DART AEROSPACE LTD		Work Order:	93806
Description: Crosstube High Fwd (205/212/412)		Part Number:	D212-664-101
Inspection Dwg: D212-664-141 Rev: D		Page 1 of 1

DRAWING NO. D212-664-141		TITLE XTUBE ASSY (205/212/412 HI FWD)		REV. D	DART AEROSPACE LTD ENGINEERING ORDER		D.E.O. NO. D212-664-141-D-1		SHEET NO. SHEET 1 OF 2		SCALE NTS
DRAWN		CHECKED		OP	MFG. APPR. <i>RE</i>		APPROVED		DE APPR. <i>MP</i>		
DATE 11.04.07		DATE 11.04.11			DATE 11.04.12		DATE 11/04/12		DATE 11.04.12

ADD AN INSPECTION WINDOW TO UNDERSIDE OF CROSSTUBE.

DRAWING NO. D212-664-141	TITLE CROSSTUBE ASS'Y (205 HI FWD)	REV. D	DART AEROSPACE LTD ENGINEERING ORDER		D.E.O. NO. D212-664-141-D-2	SHEET NO. SHEET 1 OF 1	SCALE NTS
DRAWN <i>UP</i>	CHECKED <i>ADS</i>	MFG. APPR. <i>AD</i>	APPROVED <i>MD</i>		DE APPR. <i>HH</i>		
DATE 11.07.15	DATE 11.07.20	DATE 11.07.21	DATE 11/07/21		DATE 11.07.21

DESIGN	RT	DART AEROSPACE LTD
DRAWN	RF	HAWKESBURY, ONTARIO, CANADA
CHECKED	Q	DRAWING NO.
MFG. APPR	15	D212-664-141
APPROVED	15	REV. D
DE APPR	15	SHEET 4 OF 4
DATE	09.09.30	TITLE
		XTUBE ASSY (205/212/412 HI FWD)
		SCALE
		NTS

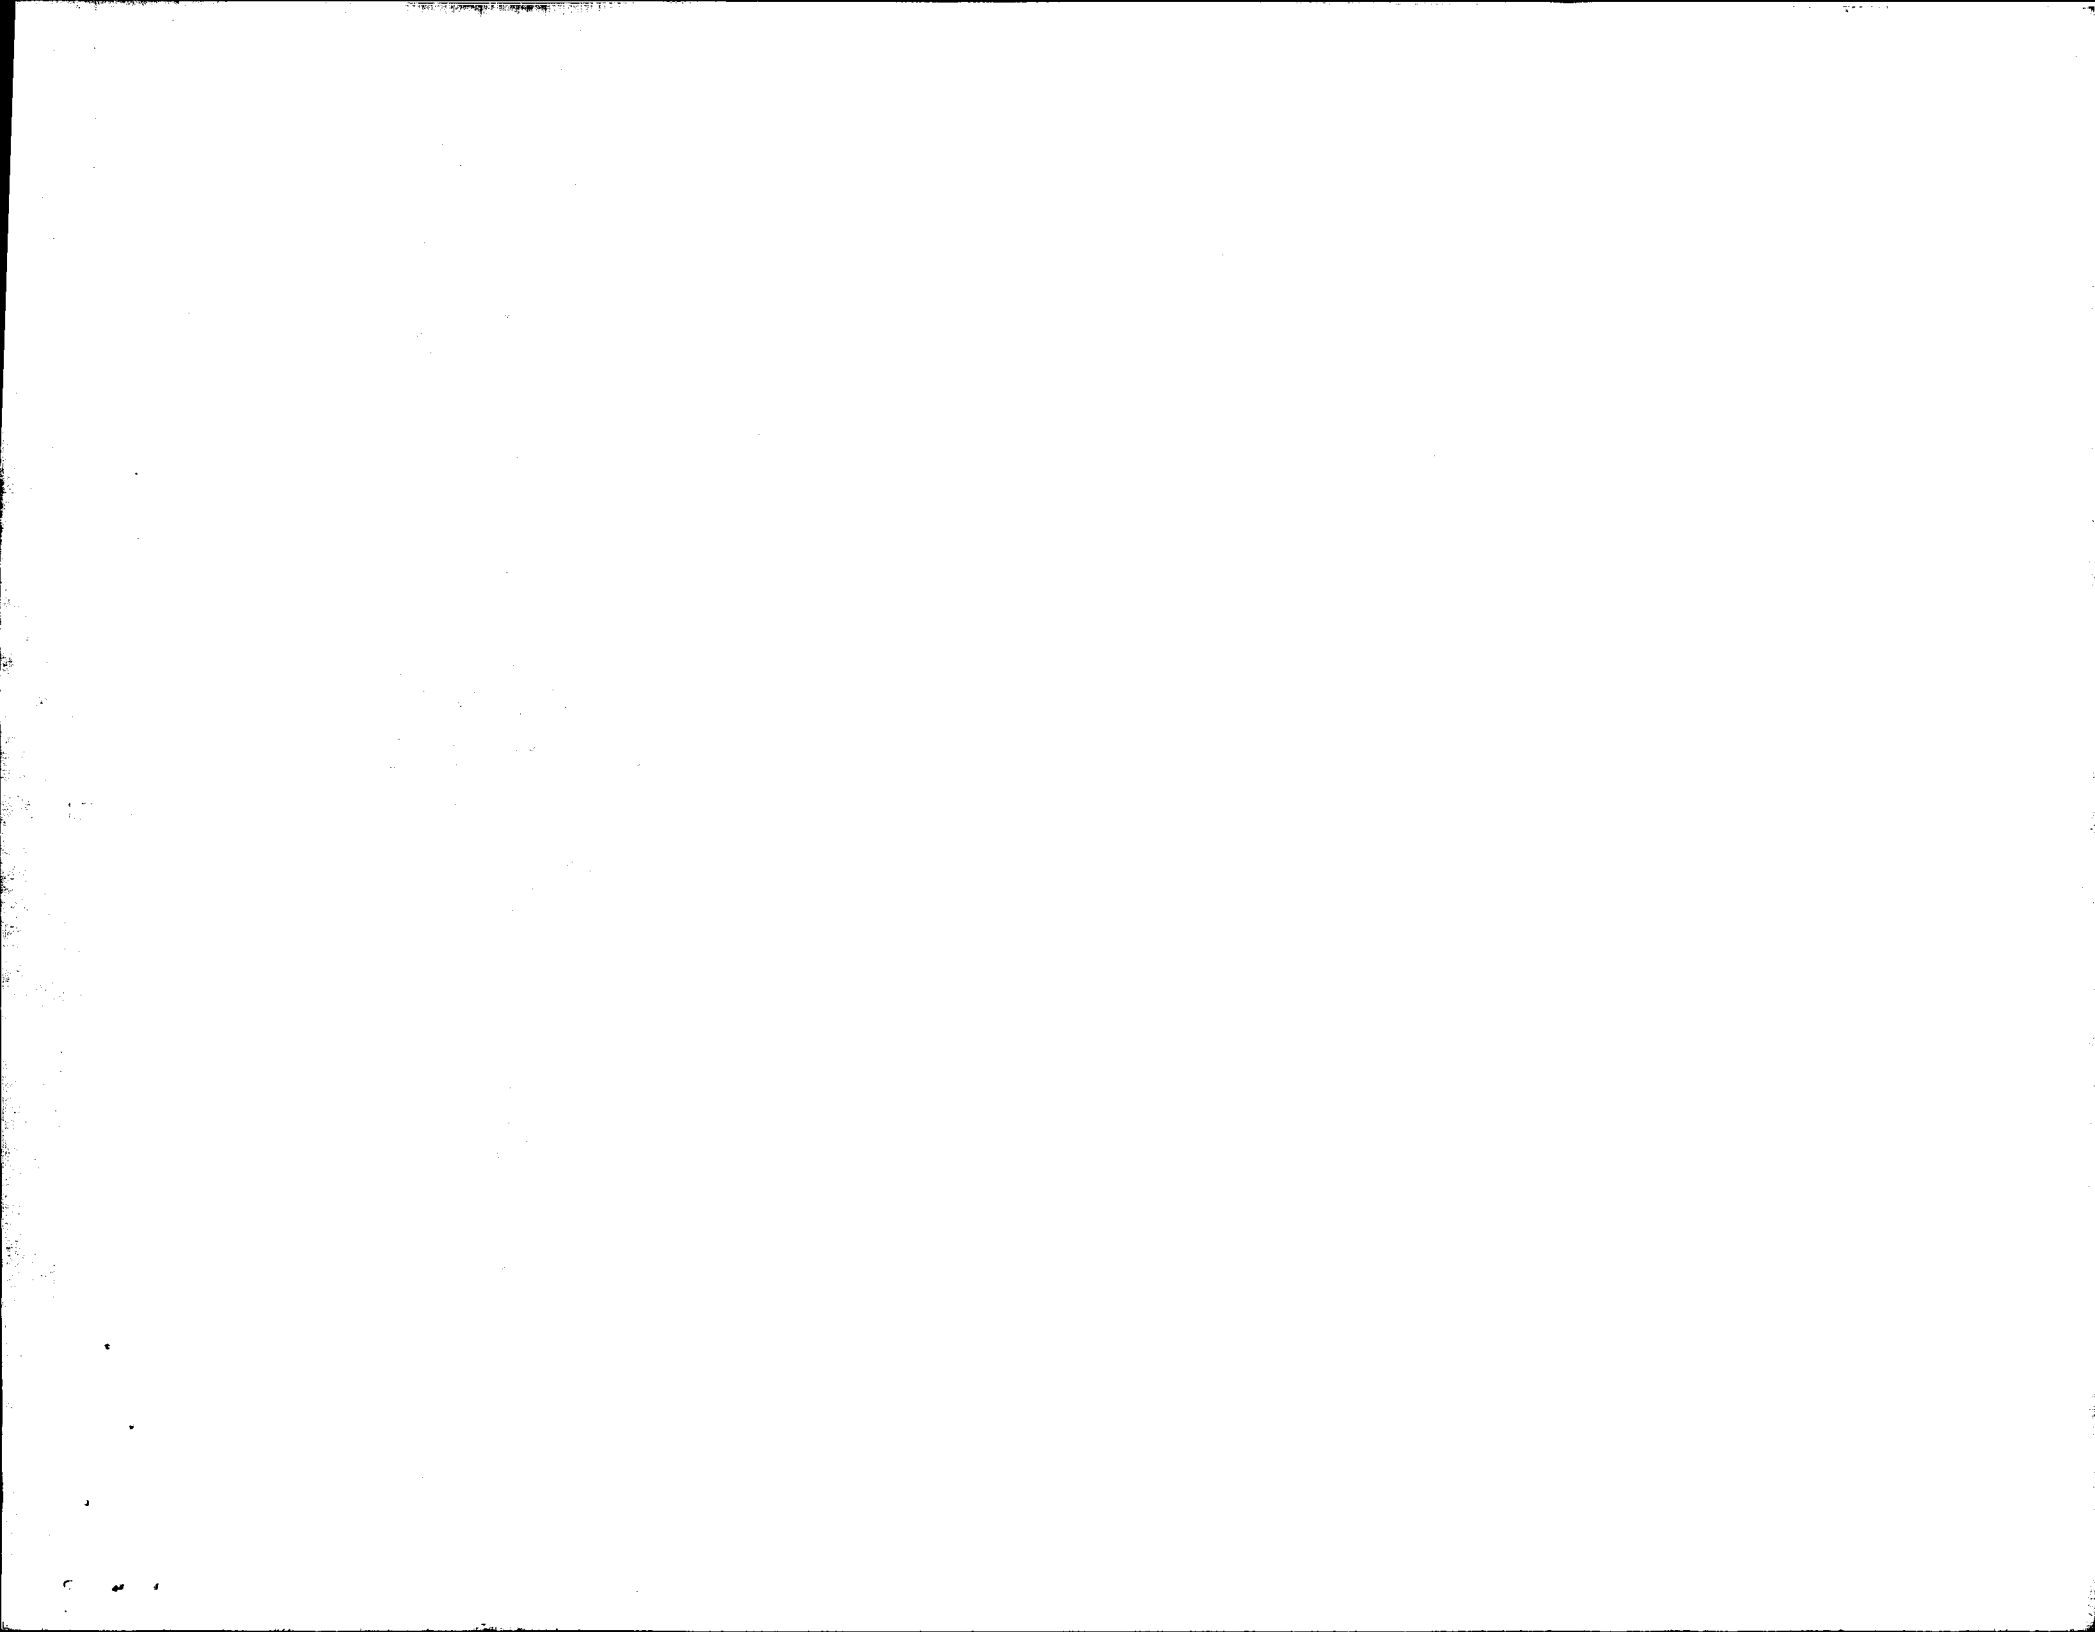
D	REFORMAT/REVISE GENERAL NOTES/PART LIST; REORGANIZED VIEWS AND REFORMATTED DRAWING TO CURRENT STANDARDS; ADD -141B (ZN B4-2, D4-2); REMOVED REF & ADD TOLERANCES (ZN B4-3, C6-3, C8-3 & B6-3); RELOCATED FLAG #6 PER PAR 08-046 (ZN A5-3); MOVED TURNING DETAIL & UPDATED TOLERANCE TO SHEET 4	RF	09.09.30
C	REMOVE -851 ABRASION STRIP; ADD MAGNOBOND 6398, CUSHION, REVERSE CLAMPS	PH	07.03.08
B	ADD HOLES FOR COMPATABILITY WITH BHT/AA SKIDTUBES	PH	05.02.04
A	NEW ISSUE	PH	00.12.12
REV.	DESCRIPTION	BY	DATE
DESIGN	PH	DART AEROSPACE LTD	
DRAWN	RF	HAWKESBURY, ONTARIO, CANADA	
CHECKED	97	DRAWING NO.	REV. D
MFG. APPR.	DS	D212-664-141	SHEET 1 OF 4
APPROVED	10	TITLE	SCALE
DE APPR.	11	XTUBE ASS'Y (205/212/412 HI FWD)	NTS
DATE	09.09.30	COPYRIGHT © 2000 BY DART AEROSPACE LTD THIS DOCUMENT IS PRIVATE AND CONFIDENTIAL AND IS SUPPLIED ON THE EXPRESS CONDITION THAT IT IS NOT TO BE USED FOR ANY PURPOSE OR COPIED OR COMMUNICATED TO ANY OTHER PERSON WITHOUT WRITTEN PERMISSION FROM DART AEROSPACE LTD.

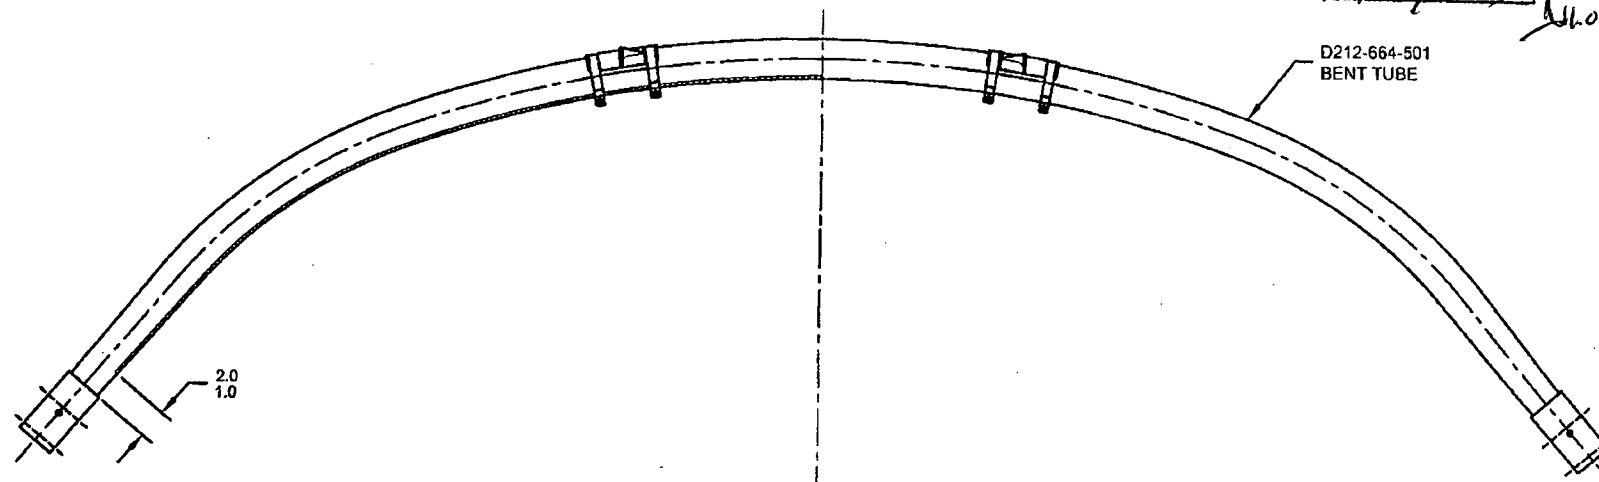
NOTES 2 OF SHEET 1 IS AMENDED AS FOLLOWS:

- 2) FINISH: CHEMICAL CONVERSION COAT PER DART QSI 005 4.1
PRIME INSIDE AND OUTSIDE PER DART QSI 005 4.2
MASK UNDERSIDE OF CROSSTUBE AS SHOWN (HATCHED AREA) AND
PAINT OUTSIDE PER DART QSI 005 4.2
REMOVE MASKING AND APPLY CLEAR COAT

MASK AREA PRIOR TO PAINTING.
REMOVE MASKING AFTER PAINT
AND APPLY CLEAR COAT
